AGENDA

1445 Woodside Avenue – Material Deconstruction – Significant House. The applicant is requesting to remove: a non-historic portico on the front façade; the front door; a secondary entrance (door, stairs, railing) on the south elevation; a rectangle of approximately 21.5 feet by 14.5 feet of the rear wall of the historic house; the roof the non-historic garage to accommodate a new second level addition; and a rectangle of approximately 19 feet by 29 feet of the non-historic garage wall. <i>Public hearing and possible action</i>	PL-15-02871 <i>Planner Grahm</i>	43
--	-------------------------------------	----

PARK CITY MUNICIPAL CORPORATION
HISTORIC PRESERVATION BOARD
MINUTES OF NOVEMBER 18, 2015

Diagram 1: Red outline shows the portion of the porch to be removed.

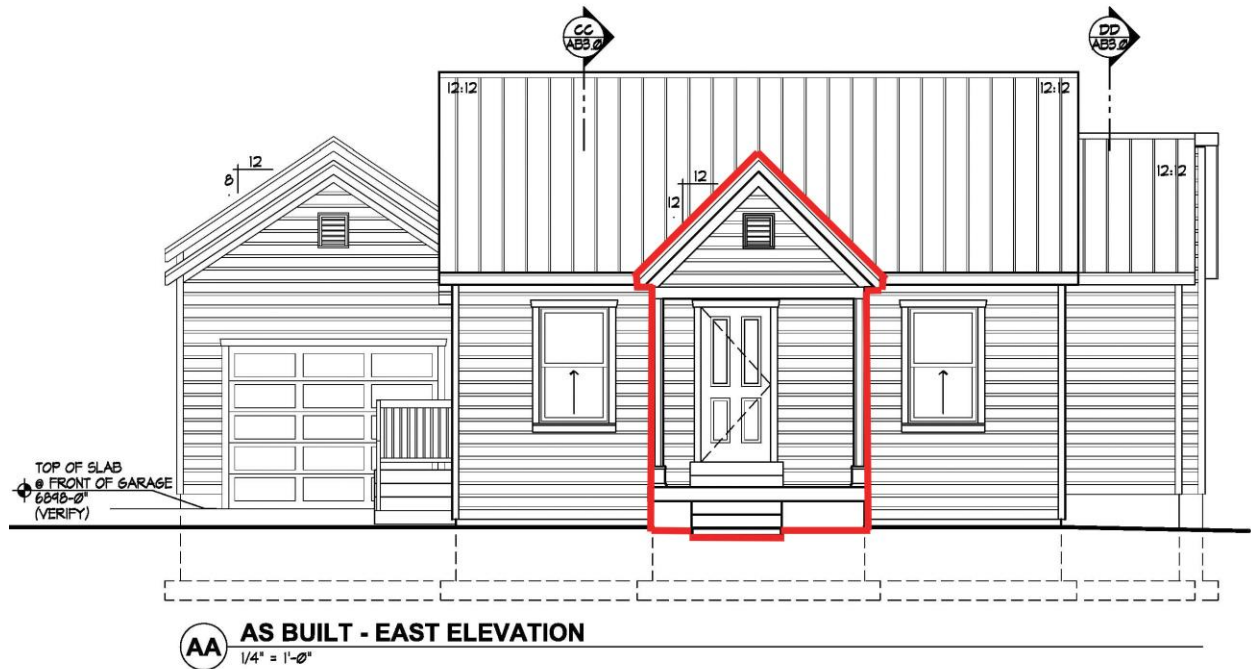
The applicant intends to remove the existing portico on the front façade. This portico serves as a covered entry to the front door and consists of a poured concrete landing, two (2) porch posts, and a gabled roof above the front door. No porch is shown on the historic Sanborn Fire Insurance Maps; however, the portico does contribute to the historic appearance of the house. The materials on the portico are not historic. The applicant will be removing the portico to replace it with a new full-width front porch that is in keeping with the style and form of the house.

As the applicant will be replacing the porch with a new full-width front porch, the proposed work mitigates any impacts that will occur to the historical significance of the building and any impact that will occur to the architectural integrity of the building.

Diagram 2: Red outline shows the door to be removed.

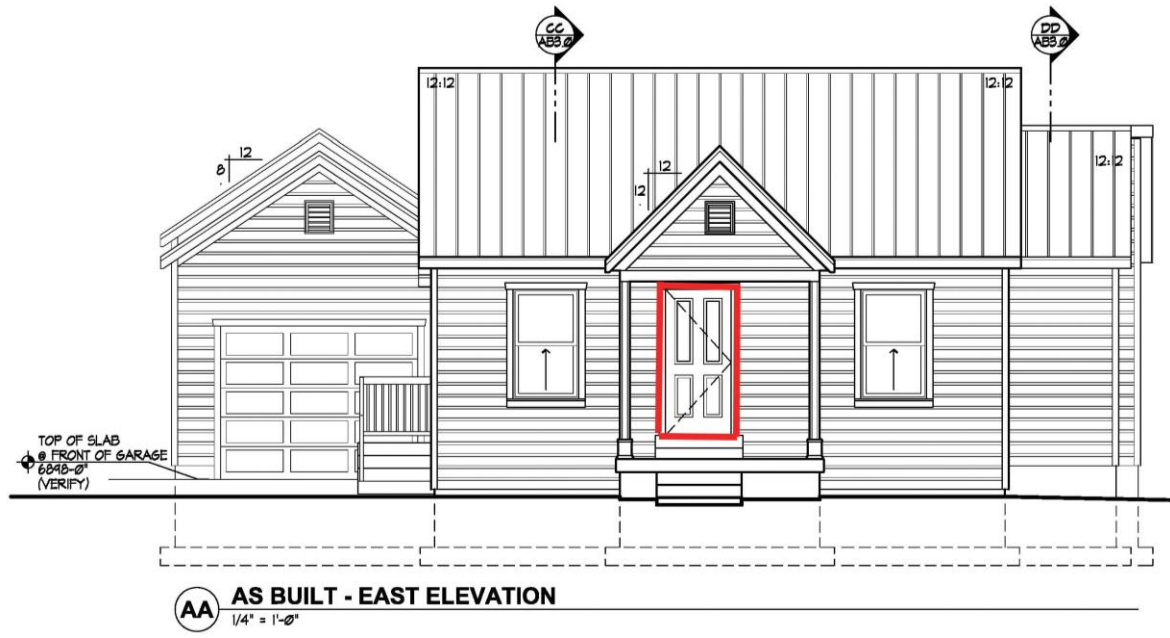
The applicant intends to remove and replace the existing front door. No changes to the size or scale of the door are proposed at this time. Staff finds the proposed exterior change shall not damage or destroy the exterior architectural features of the subject property which are compatible with the character of the historic site.

Diagram 3: Red outline shows the side entrance and door to be removed.

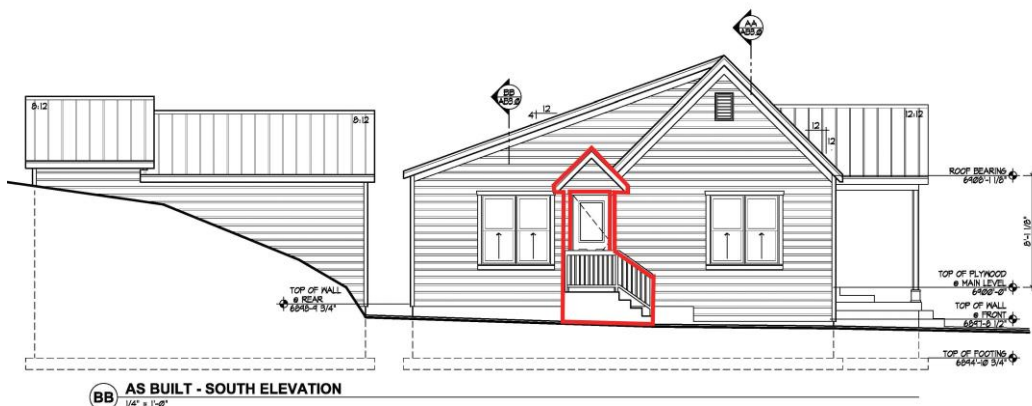
There is an existing side entrance to the house on the south elevation, accessible from the driveway. This entrance consists of a door, projecting gable roof, concrete stairs and landing, and wood railing. The location of this door is centered between the gable of the hall-parlor and the shed-roof addition, suggesting that it was not original to the historic house. The applicant intends to remove this entrance altogether and re-patch the wall with siding to match the existing.

Staff finds that the proposed exterior change shall not damage or destroy the exterior architectural features of the subject property which are compatible with the character of the historic site.

Diagram 4: The red outline shows the portion of the rear wall that will be removed to accommodate the new addition.

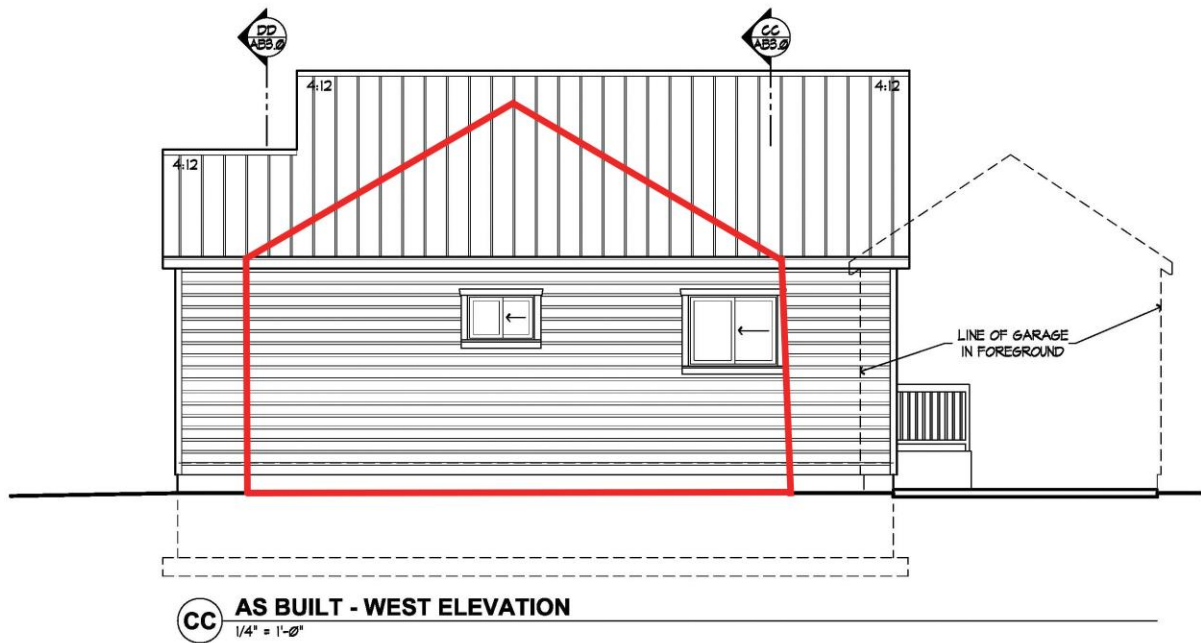
4. Remove a portion of the rear wall of the historic house, measuring approximately 21.5 feet by 14.5 feet, as well as a portion of the roof on the rear of the house. In order to accommodate the new rear addition, which will connect the back of the house to the garage, the applicant intends to remove a portion of the rear wall of the existing house. This shed-roof addition was constructed as part of the 1993-1996 remodel/reconstruction. It is not constructed of historic materials.

Staff finds that the proposed partial demolition is required for the renovation of the building.

Diagram 5: The red outline shows the portion of the garage that will be removed.

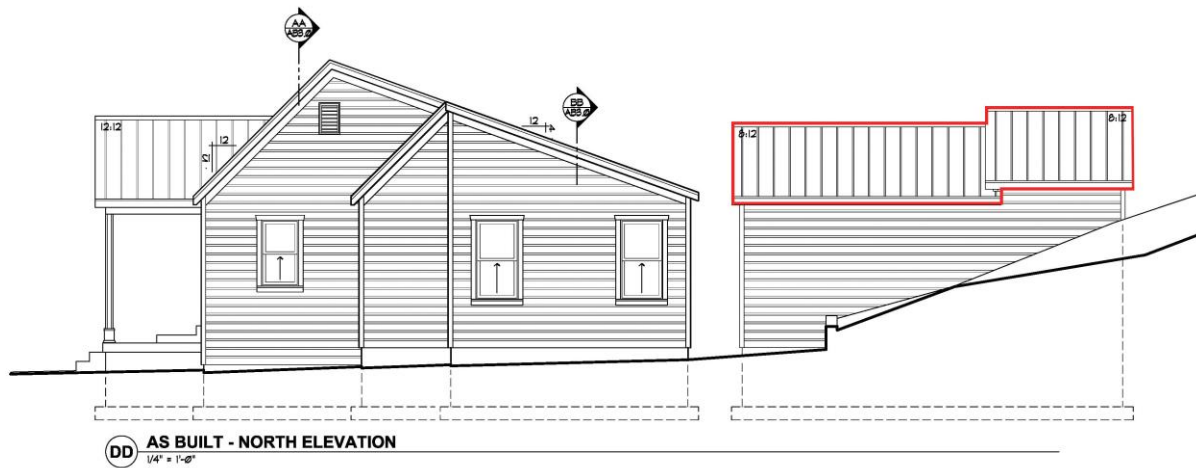
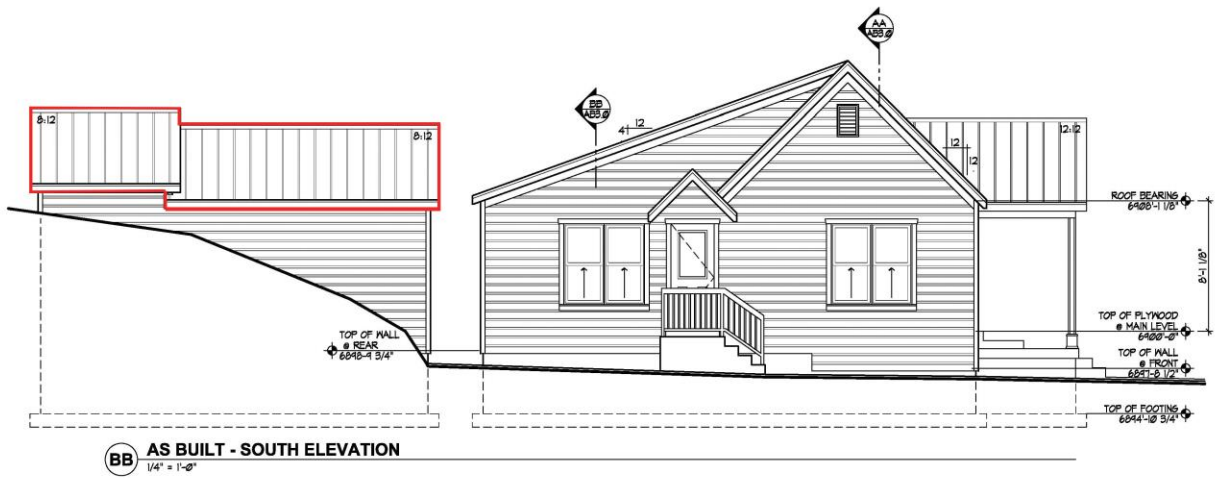
5. Remove the gable roof of the non-historic garage. The applicant intends to remove the gable roof of the non-historic garage in order to construct a second level living space above the existing garage. This garage is not a historic reconstruction, but rather was a new addition to the site constructed in 1993. The applicant will remove the roof in its entirety to construct the new second floor addition.

Staff finds that the proposed partial demolition is required for the renovation of the building.

Diagram 6: The red outline shows the portion of the garage wall to be removed.

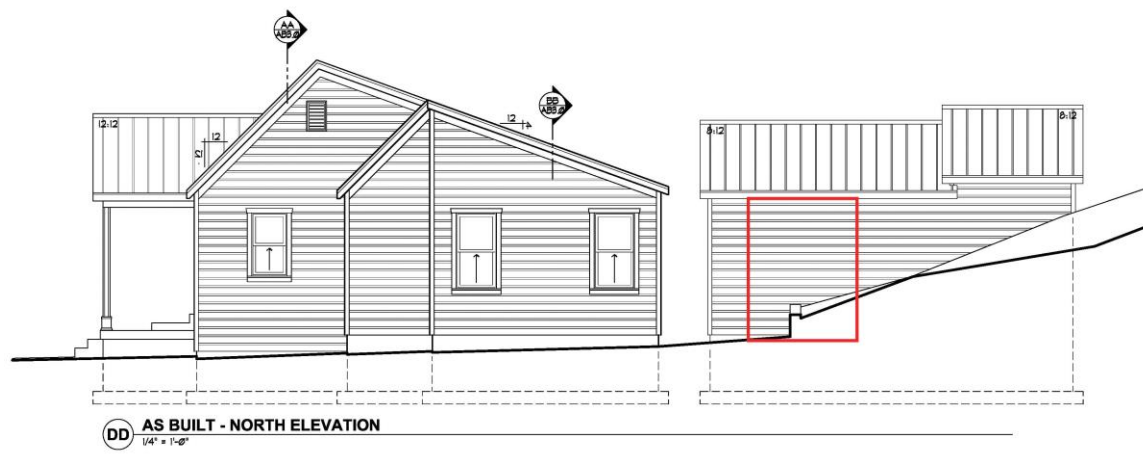
6. Remove a portion of the north wall of the non-historic garage, measuring approximately 19 feet by 29 feet.

The applicant will remove a portion of the non-historic garage wall in order to connect the new addition to the garage. As previously mentioned, the garage was constructed c.1993 and is not historic, nor is the garage a historic reconstruction.

Staff finds that the proposed partial demolition is required for the renovation of the building.
